Date: 2/14/08
To: All Contractors/Vendors
From: Linda M. Martin, Clerk
Subject: Addendum Number: 3
Project Name: Eddy Street Commons Phase II Parking Garage
Project Number: 108-004

ADDENDUM # 3

PROJECT: Eddy Street Commons Phase II Parking Garage
1200 Edison Road
South Bend, Indiana

**Addendum No. 3
February 14, 2008**

Reference Drawing: **S101**

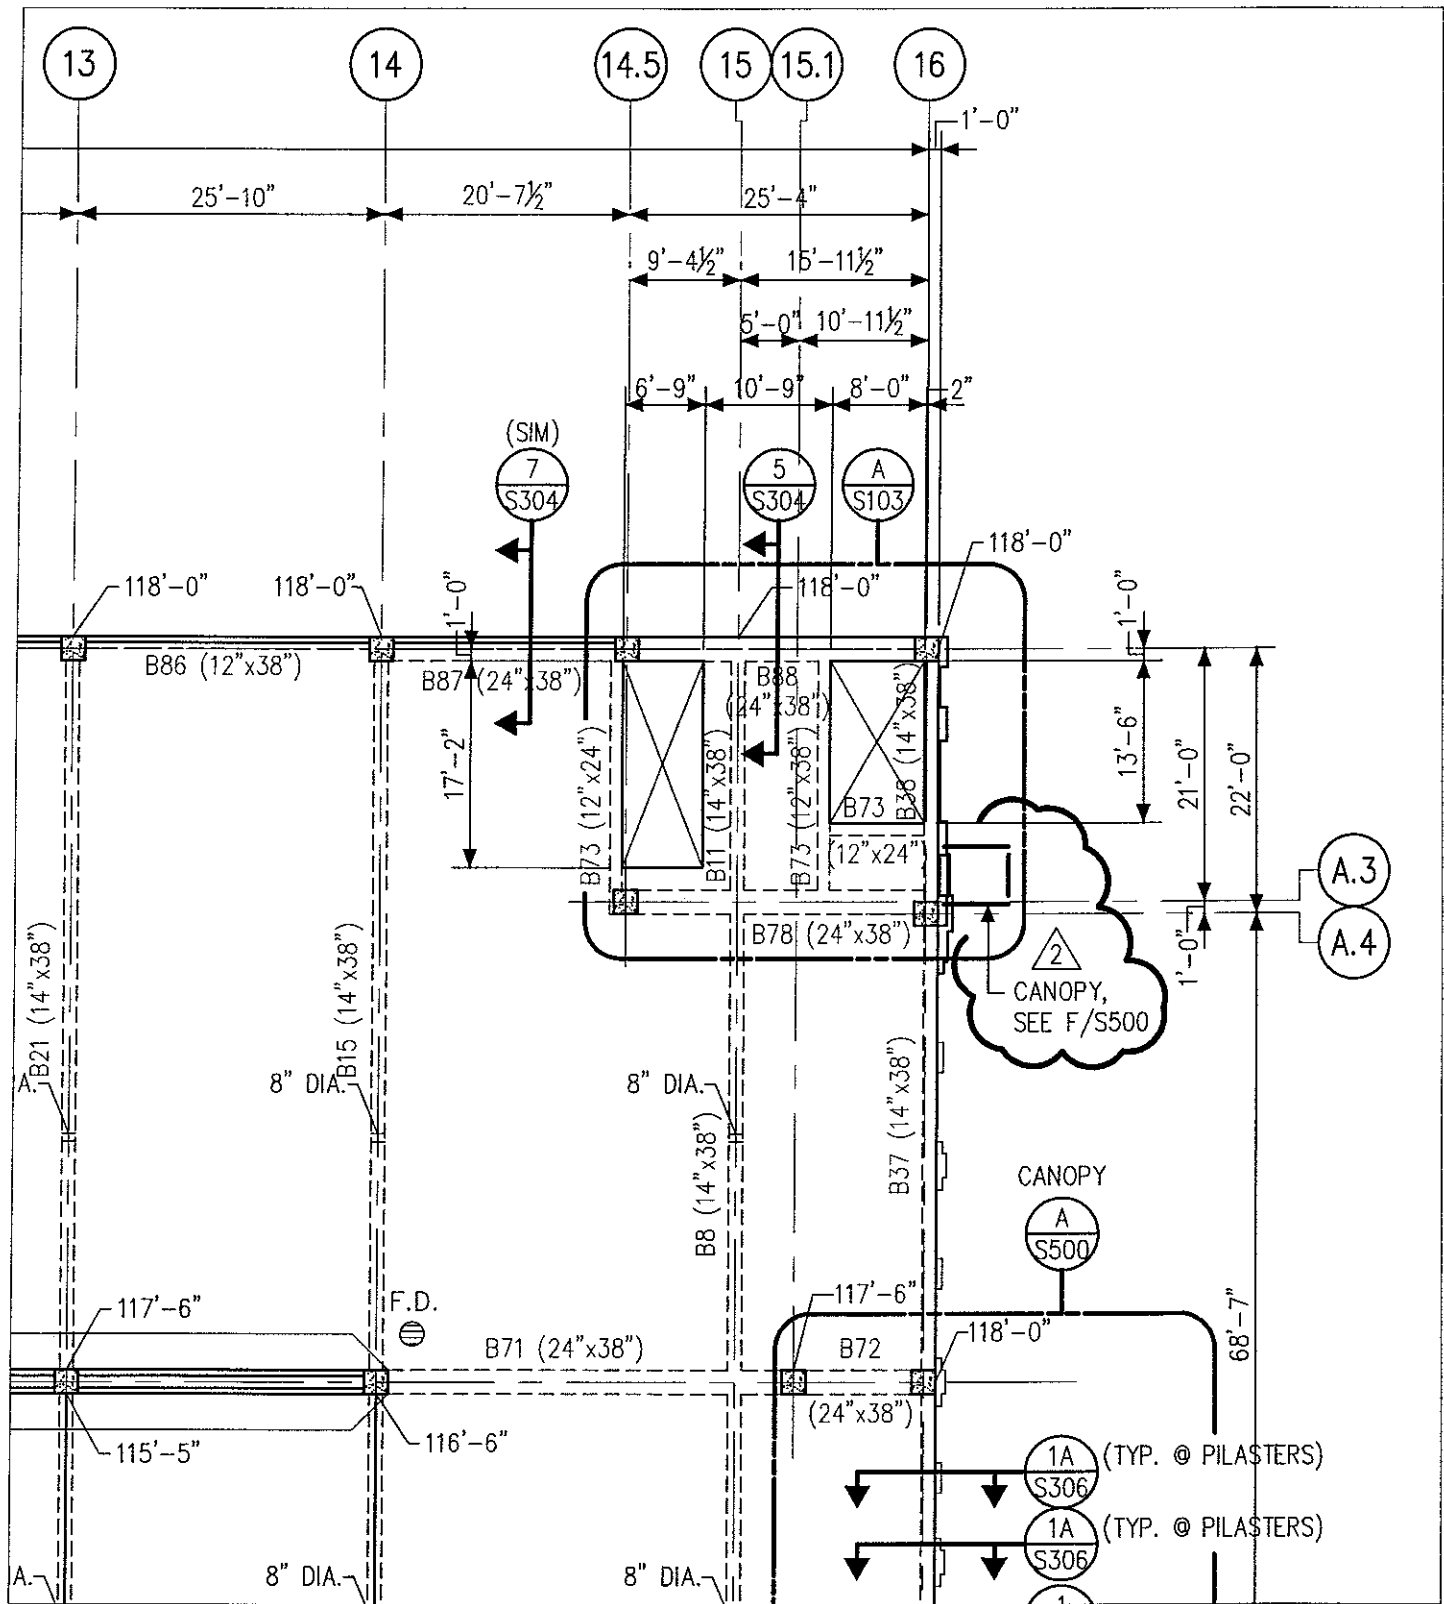
1. Add Section cuts as indicated on attached sketch S-SK001.

Addendum No. 3
02-14-08
Reference Drawing: S301
Revision Number: 2
Drawn by: SVC Checked by: JMP
Project No.: 108-004 Scale: NONE
Drawing No.:
S-SK003

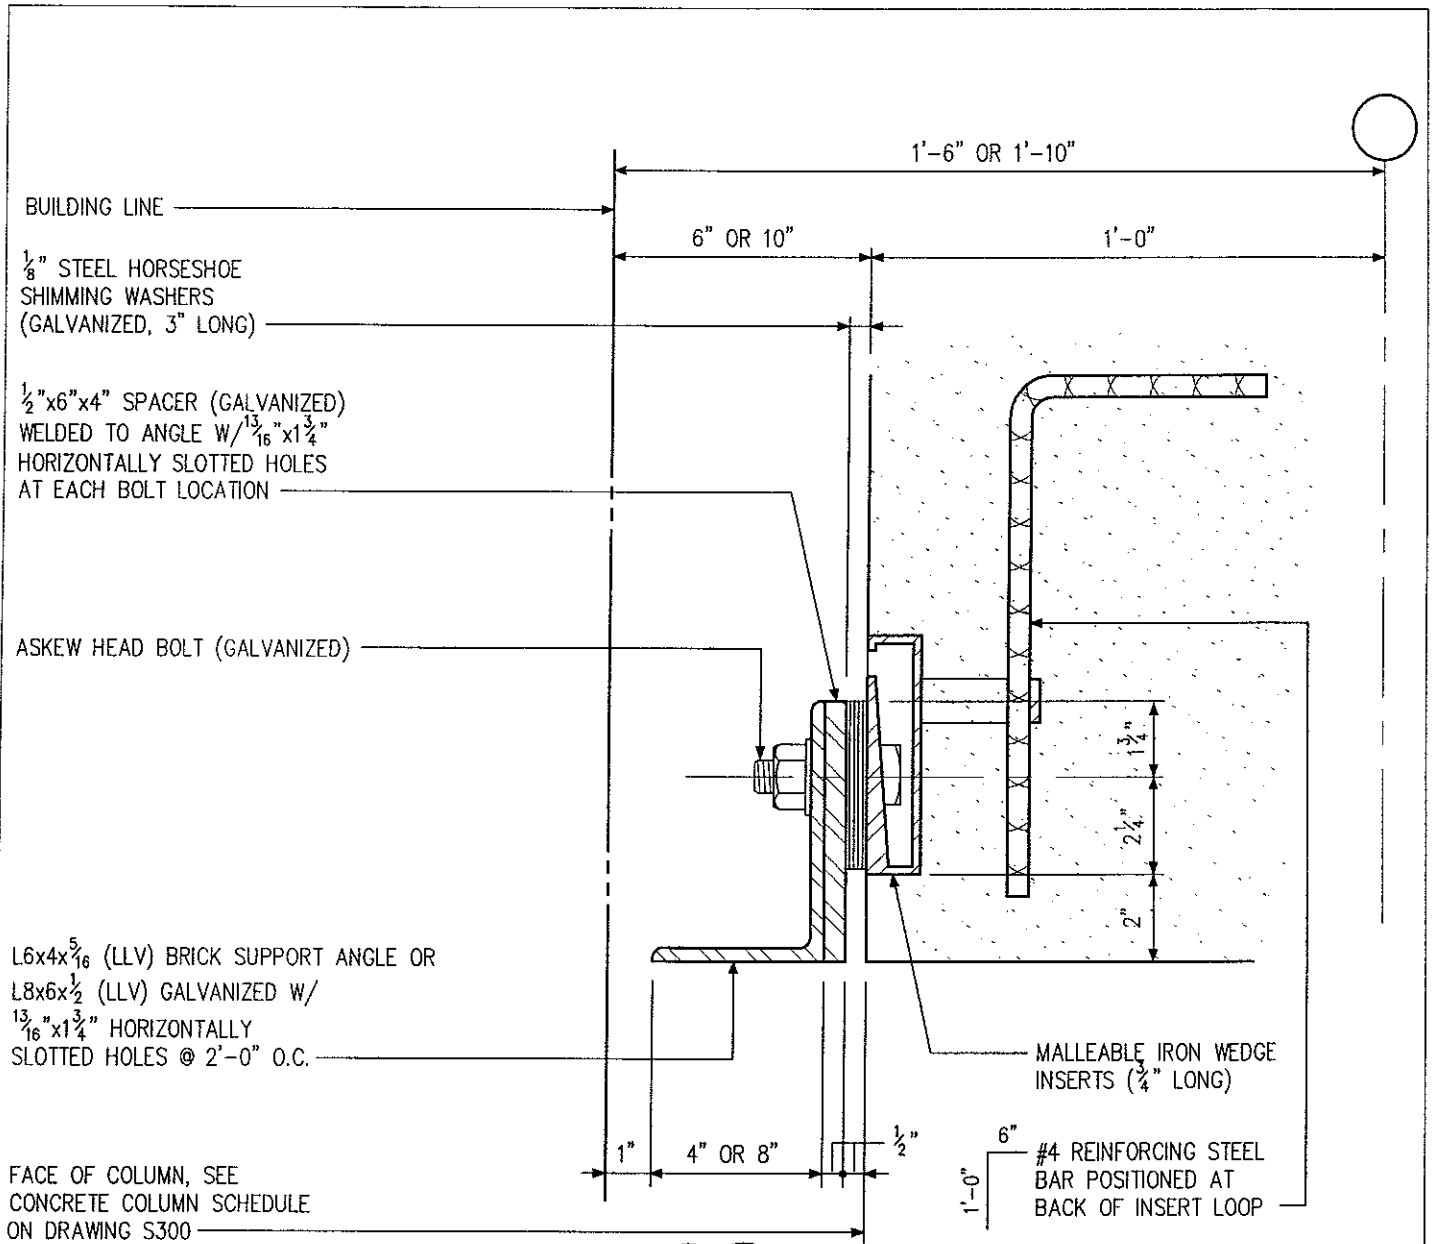
1. Revise Beam Schedule as noted on attached sketch S-SK003.

Reference Drawing: S400

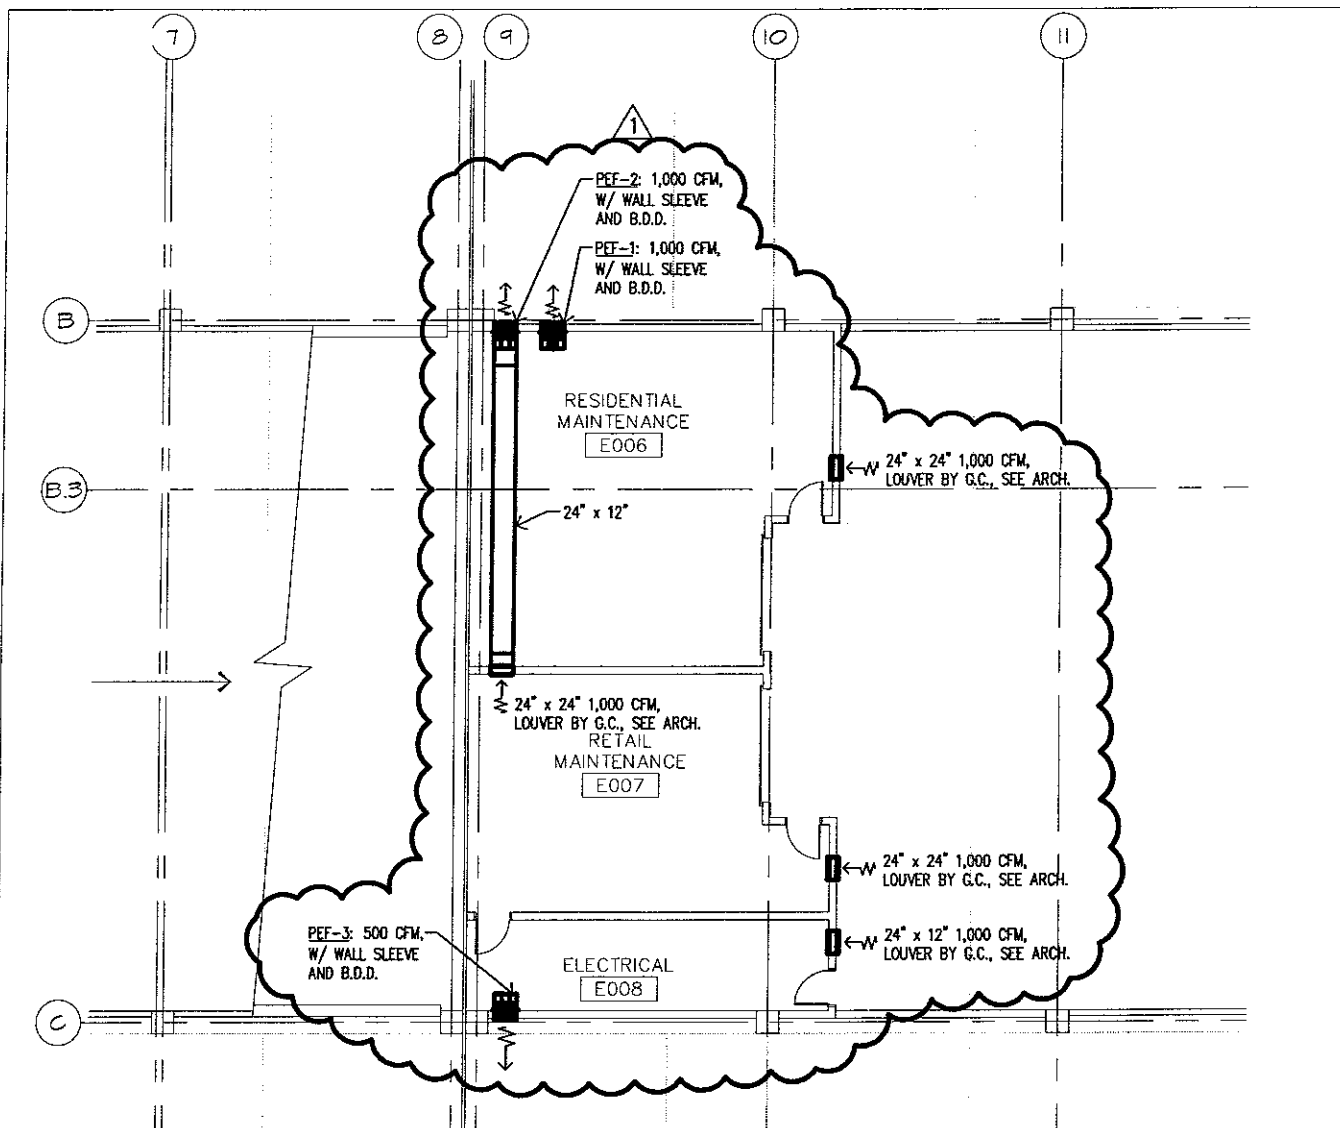
1. Add CMU Wall Vertical Reinforcing Schedule as indicated on attached sketch S-SK005.

Addendum No. 3
02-14-08
Reference Drawing: H201
Revision Number: 1
Drawn by: KFY Checked by: JLW
Project No.: 108-004 Scale: 1/16" = 1'-0"
Drawing No.:
H-SK001

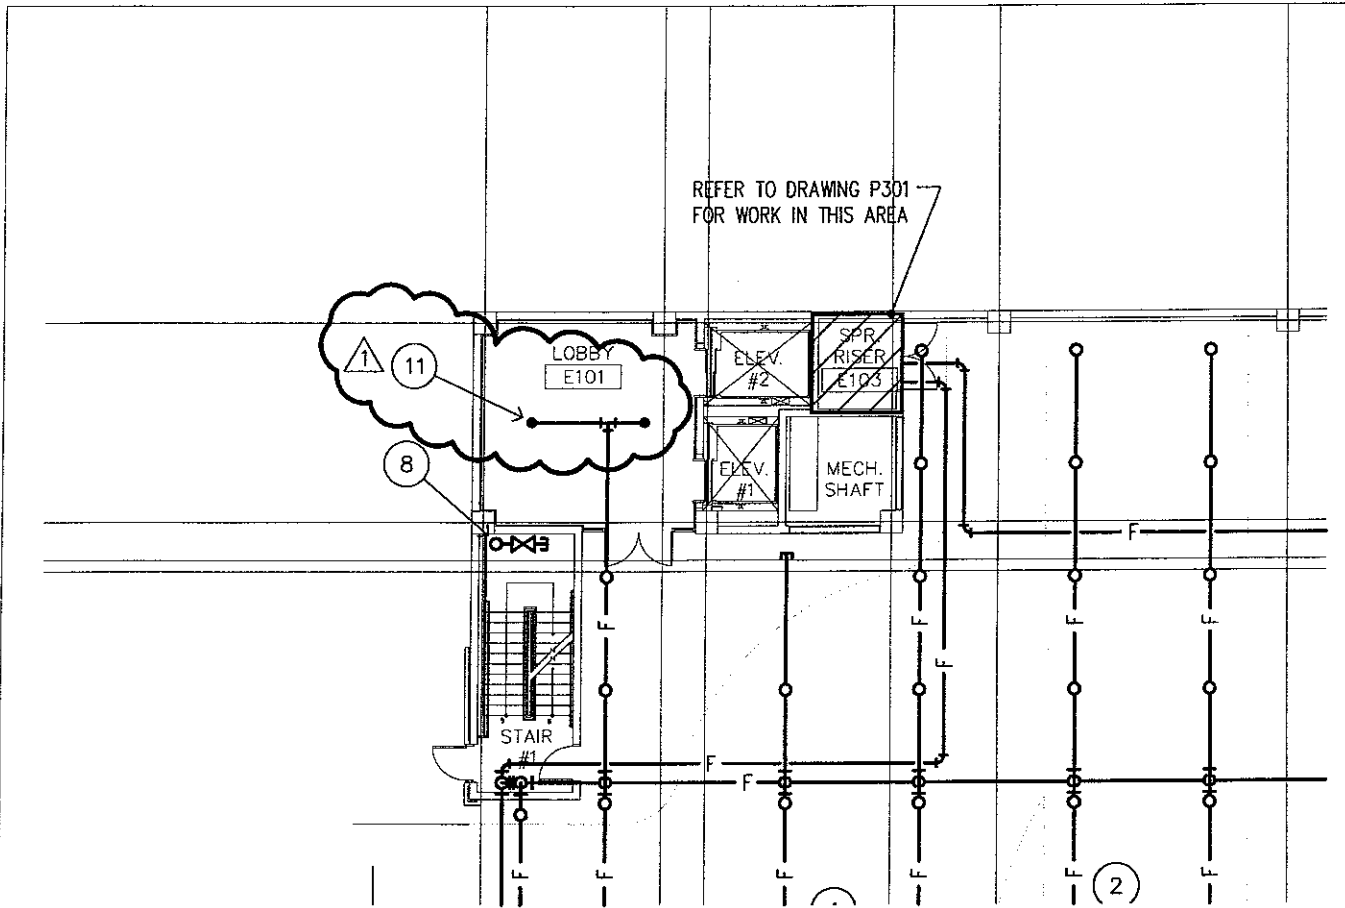
1. Revise ventilation system for the storage and electrical rooms as shown on attached Sketch H-SK001.

Addendum No. 3
 02-14-08
 Reference Drawing: P203
 Revision Number: 1
 Drawn by: REM Checked by: GAC
 Project No.: 108-004 Scale: 1/16" = 1'-0"
 Drawing No.:

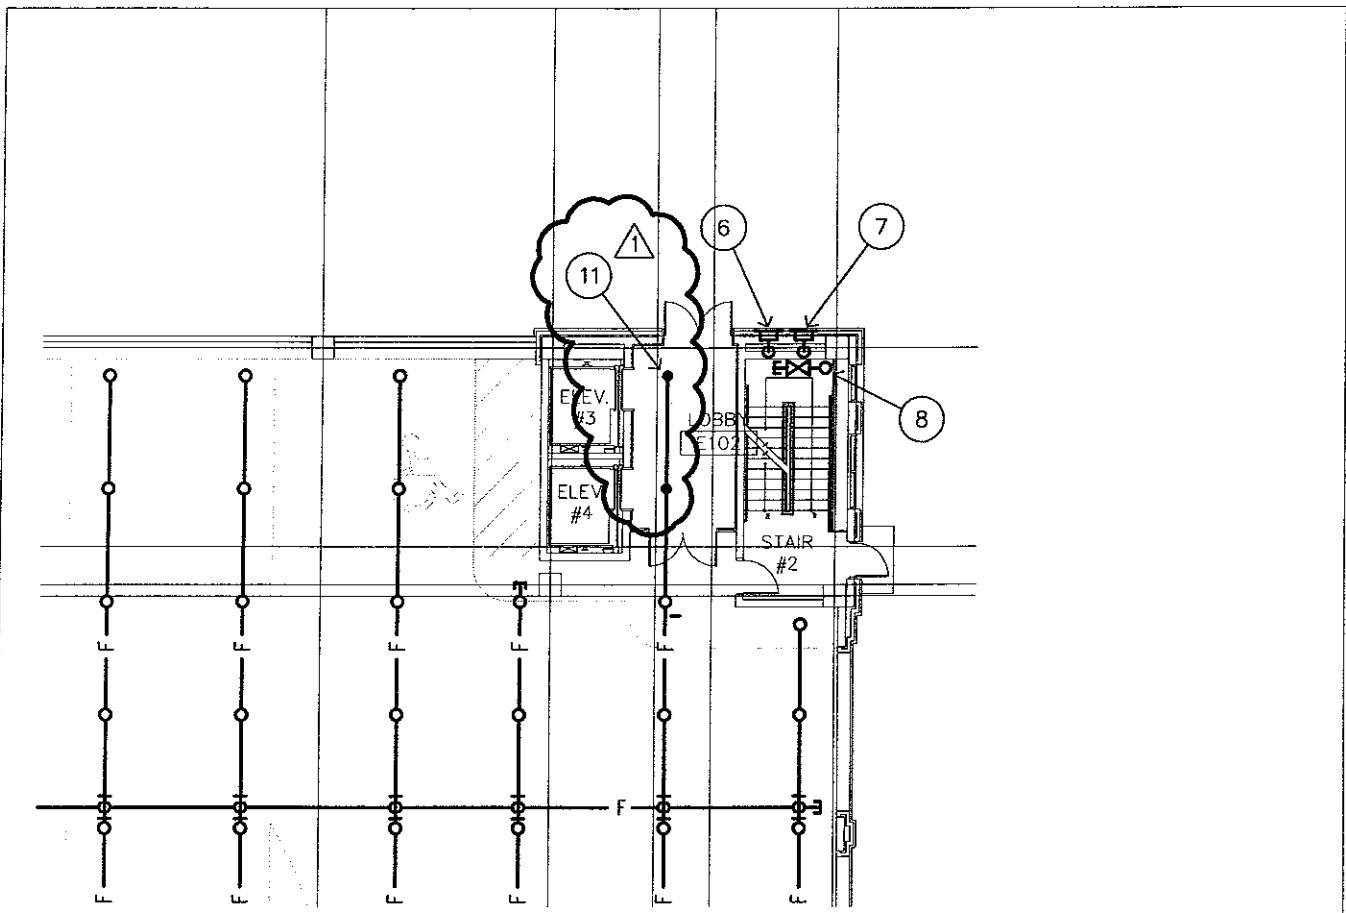
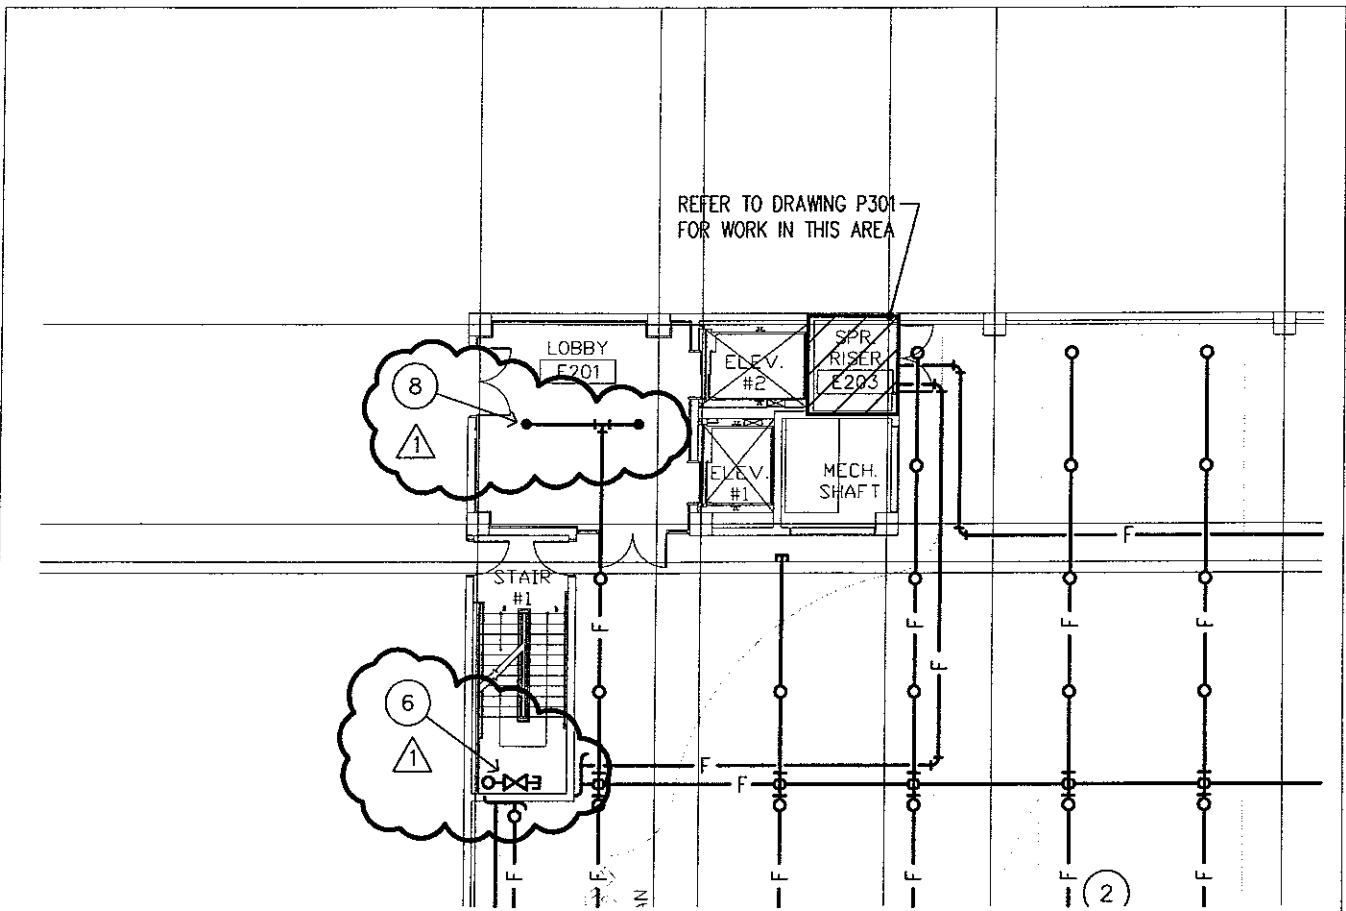
1. Change upright sprinkler heads in elevator lobbies to recessed pendant sprinkler heads as shown on attached Sketches P-SK004 and P-SK005.
2. Change finished floor elevation to 742.00'.
